# Karanga-a-hape Station Neighbourhood Improvements Project

75 % Detailed Design

Safe System Audit

22 December 2023

**Figure 25: Proposed pram crossing on Cross Street**

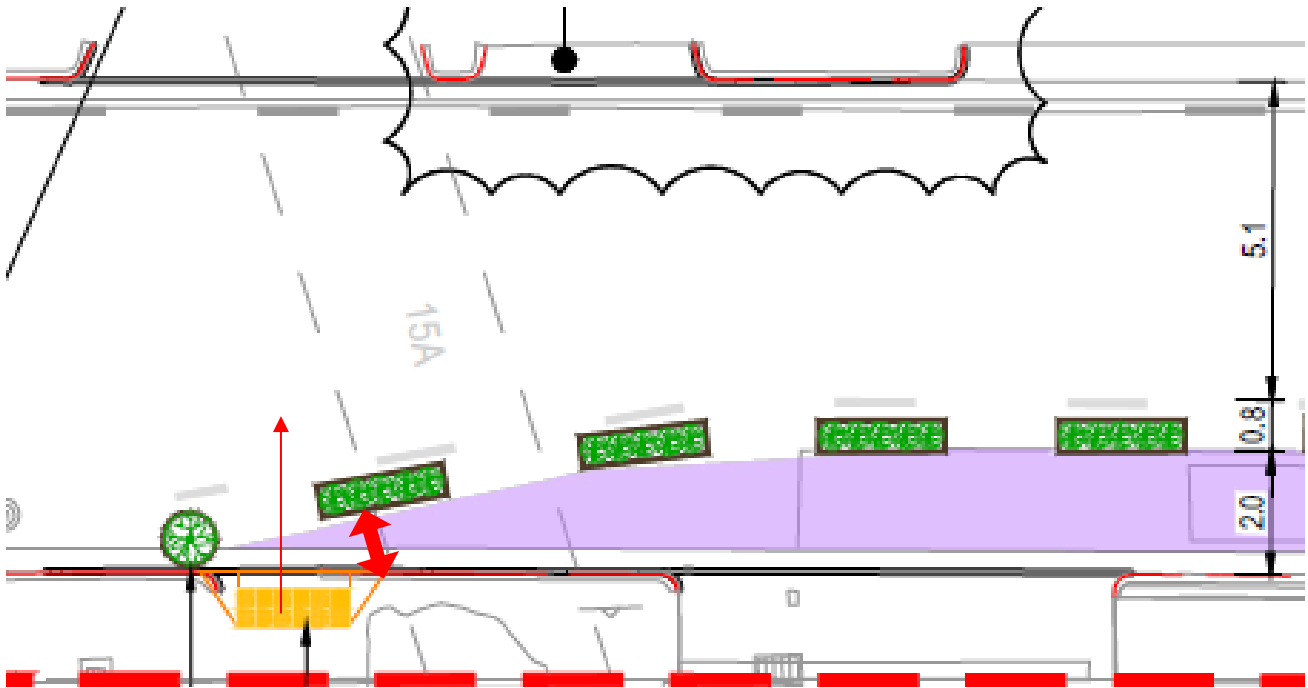
A new pram crossing proposed on Cross Street is shown in Figure 25.

The location where the pram crossing is proposed will not provide enough space for a pram or a wheelchair to manoeuvre between the road kerb and the planter box. The tactile pavers also incorrectly suggest a crossing direction across Cross Street, rather than continuing along Cross Street. The audit team also noted there is an existing potential trip hazard approximately 5 m beyond the proposed pram crossing where there is an uneven step from the footpath down to a disused vehicle crossing. Refer to Figure 26.

- 1 Consider omitting the pram crossing and instead adapting the wide abandoned vehicle crossing (as suggested in Figure 26) to facilitate the movement of pedestrians from the footpath across into the protected road shoulder area. This would provide an additional benefit of addressing an existing trip hazard.

**Figure 27: Upper Queen Street / Cross Street intersection**

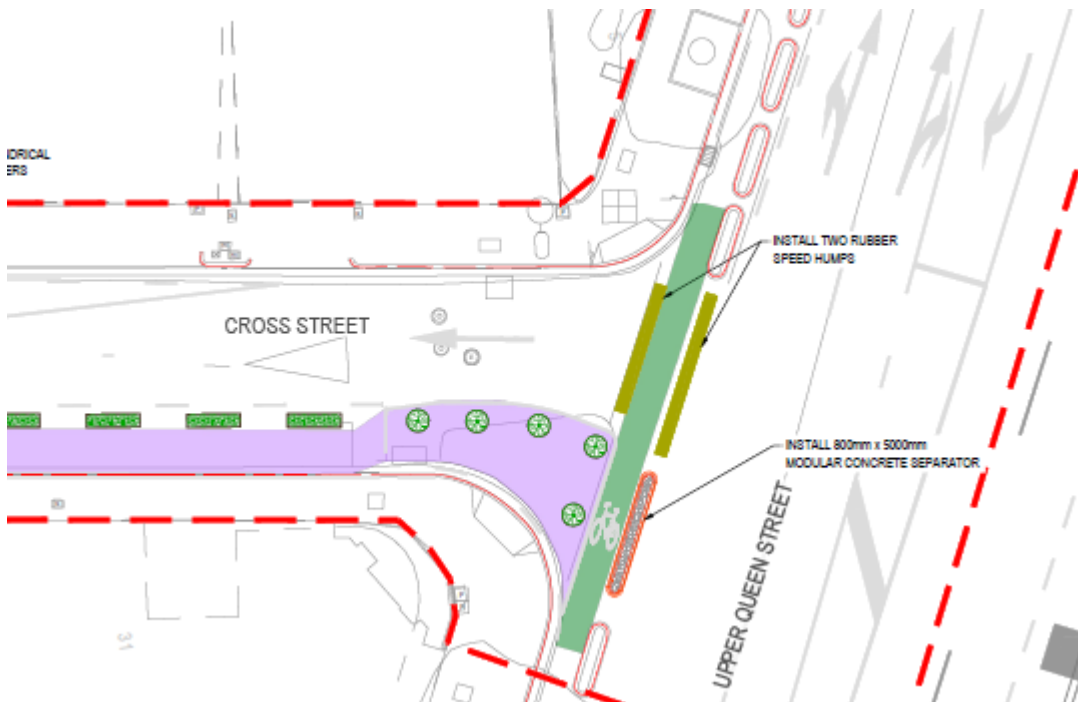
The proposed amendments to the intersection between Upper Queen Street and Cross Street are shown in Figure 27.

- 3 The leftmost northbound lane on Upper Queen Street is still incorrectly shows the existing lane making as a 'through left' lane. On site it is marked as a left only lane. The developed design audit confirmed that this lane will remain a left turn only lane and that the drawings need to be corrected. The drawings have not yet been updated to show this.

Figure 28: Proposed connection to The Lightpath

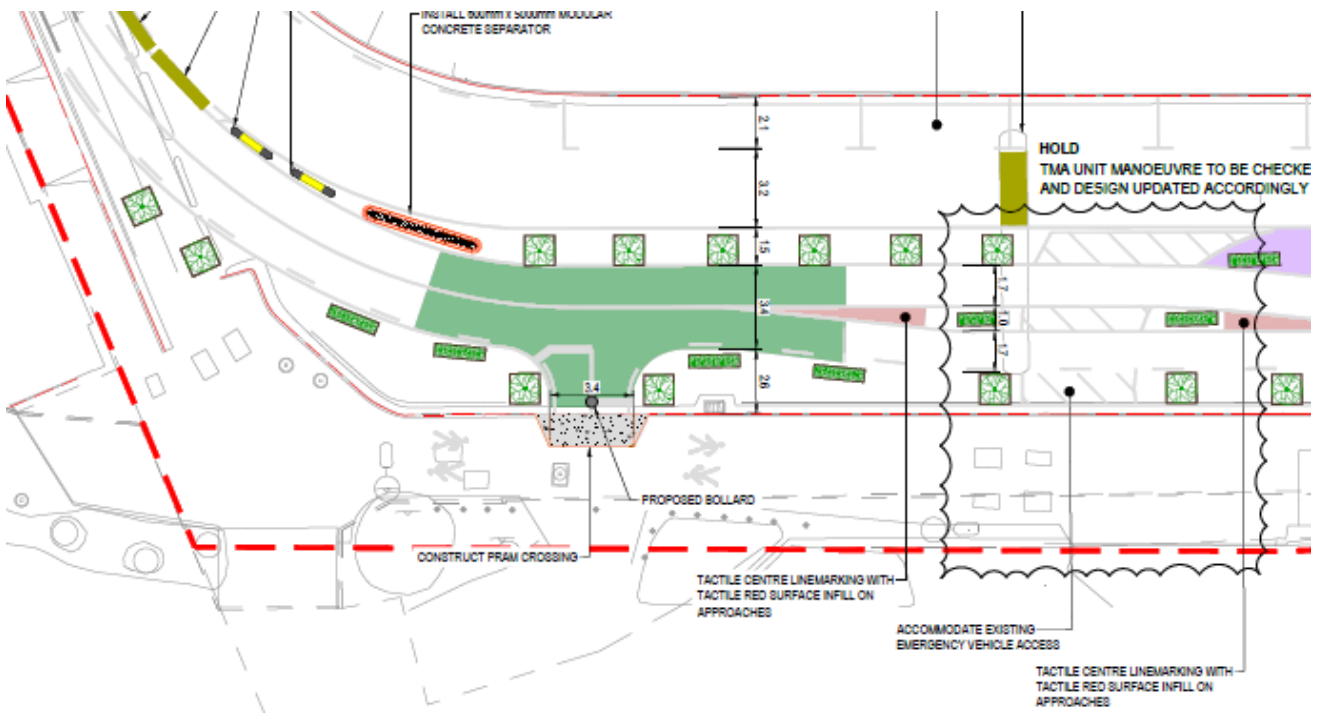
The pedestrian and cycling connection between The Lightpath and the Canada Street two-way cycleway will cross the Canada Street footpath. The updated design does not propose to flag this conflict risk area to pedestrians or cyclists. There are limit lines for cyclists prior to crossing the footpath area but no but no zebra markings or clear reason for cyclists to stop at the limit line. It would be safer to clearly assign priority (e.g., with a zebra crossing), rather than hope that pedestrians and cyclists will work out who should give way to whom.

The intervisibility between The Lightpath users and the footpath along Canada Street has been a safety concern since safety audits of the design phase of The Lightpath. Minor improvements to slow speeds between The Lightpath and the shared path along Canada Street were made after one or two serious crashes caused by high speed and lack of intervisibility around corners. The poor visibility can be appreciated in Figure 29.

The proposed reinstatement of the shared path to a footpath along Canada Street will mitigate some of the safety concerns associated with the existing layout, but The Lightpath connection will still cross the footpath in an area where intervisibility is still obstructed by the substation, vegetation, and the high fence shown in Figure 29.

Figure 31: A suggested improvement in priority indication

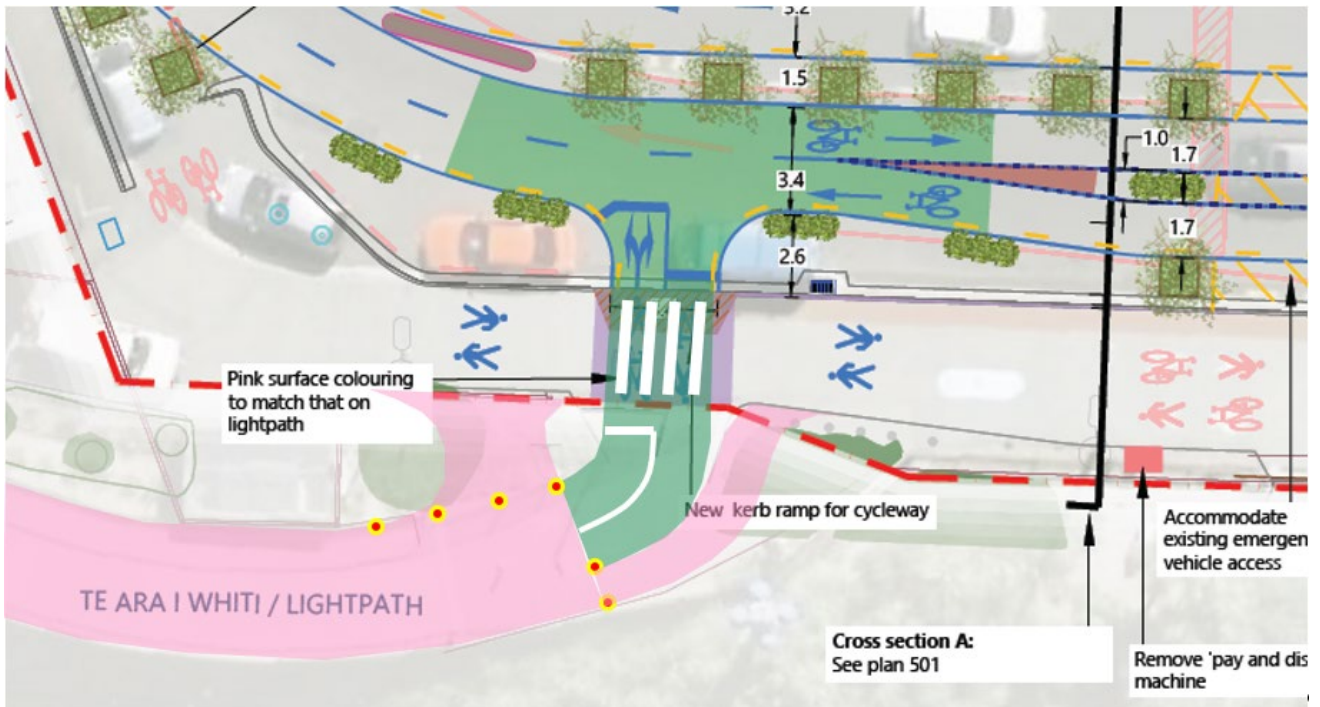
A suggested improvement is shown in Figure 31. This would extend the cycleway to the start of The Lightpath and give a clearer indication of priority of pedestrians over cyclists. This is based on the removal of the vegetation and fencing as indicated in Figure 20.

**Figure 32: Upper Queen Street / Cross Street intersection**

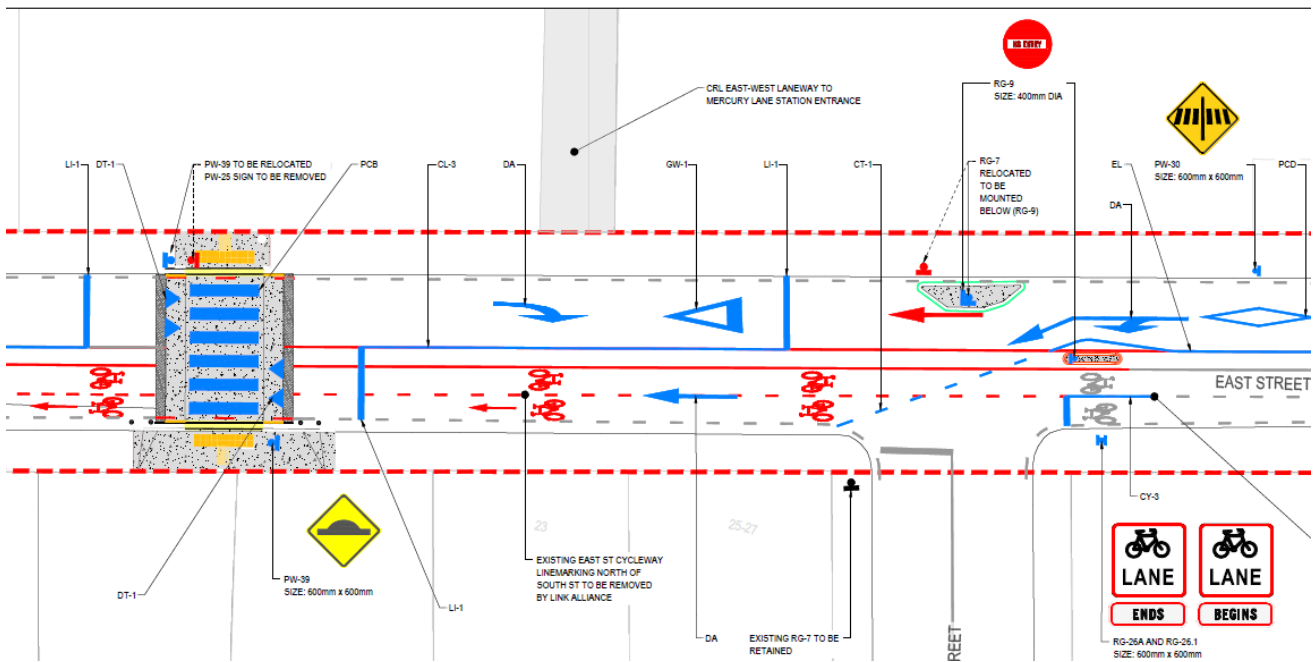
The design has been updated on East Street and the existing separated cycle path now terminates South Street rather than extending up to Galatos Street. Refer to Figure 27.
